SUBJECT: NuScale Power, LLC Response to NRC Request for Additional Information No. 317 (eRAI No. 9254) on the NuScale Design Certification Application

eRAI No.: 9254

NRC Question No.: 03.07.02-33

Figure 1: Plan View Dimensions of the Exterior Shear Walls

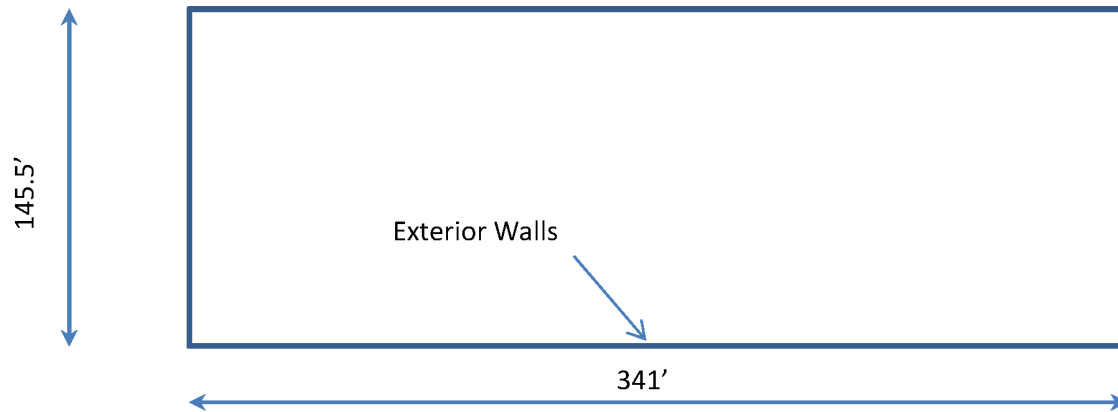
The staff reviewed the applicant's approach to addressing accidental torsion by increasing the horizontal element forces by 5% in lieu of increasing the eccentricity by 5%. The staff is unable to determine the validity of the applicant's approach that involves a uniform increase of horizontal element forces by 5% in contrast to the DSRS methodology that involves an increase of 5% torsional eccentricity on a floor level. DSRS 3.7.2, Acceptance Criteria II.11 specifies that, to account for accidental torsion, an additional eccentricity of plus or minus 5% of the maximum building dimension should be assumed for both horizontal directions and that the magnitude and location of the two eccentricities are determined separately for each floor elevation. The staff also notes that similar guidance on accounting for accidental torsion is available in industry standards; e.g., ASCE 4-16 specifies that the effect of accidental torsion be calculated at each floor level by static analysis assuming a torsional moment equal to the product of the story shear and 5% of the plan dimension perpendicular to the direction of motion of the structure at that level.

The staff finds that the applicant has not demonstrated that an eccentricity of 5% of the building

dimension is equivalent to a 5% increase in the elemental horizontal forces. Therefore, the applicant is requested to provide additional information that provides the requested technical justification to demonstrate the equivalency to the DSRS methodology or conservatism in the method used by the applicant. Compliance with the DSRS is not a requirement; however, the applicant should identify differences between the analytical methods used for its design and the DSRS acceptance criteria and evaluate the technical acceptability of its methods. The applicant may choose to use a smaller model to illustrate the comparison of the results from the two approaches.

The lateral load-resisting system of the reactor building is the reinforced concrete shear walls. The most efficient shear walls to resist the torsional effects are the exterior walls along the perimeter of the building. Only these exterior walls are considered to resist accidental torsion; the effects of the interior walls are conservatively ignored. This reduces the problem to a closed, thin-wall section subject to torsional effects. The additional shear in the walls is calculated and compared with direct shear due to direct base shear to show technical justification that the 5% amplification factor of the seismic demand is conservatively equivalent to the 5% mass offset method for addressing accidental torsion.

Shear stresses in the exterior walls (plan view shown in Figure 1) due to both direct base shear and accidental torsion are calculated. Comparing the difference between them will show the significance of accidental torsion in the seismic demands.

Direct base shear creates in-plane shear on the 5 foot thick exterior walls that are parallel to the base shear. Due to the rigid diaphragms in the reactor building, under direct shear, all exterior walls will experience the same shear stress, to satisfy deformation compatibility.

As shown by these calculations, the effect of accidental torsion is 5% of the effect of direct base shear. This, in turn, indicates that, to equivalently account for accidental torsion effects, seismic demands can be increased by 5%.
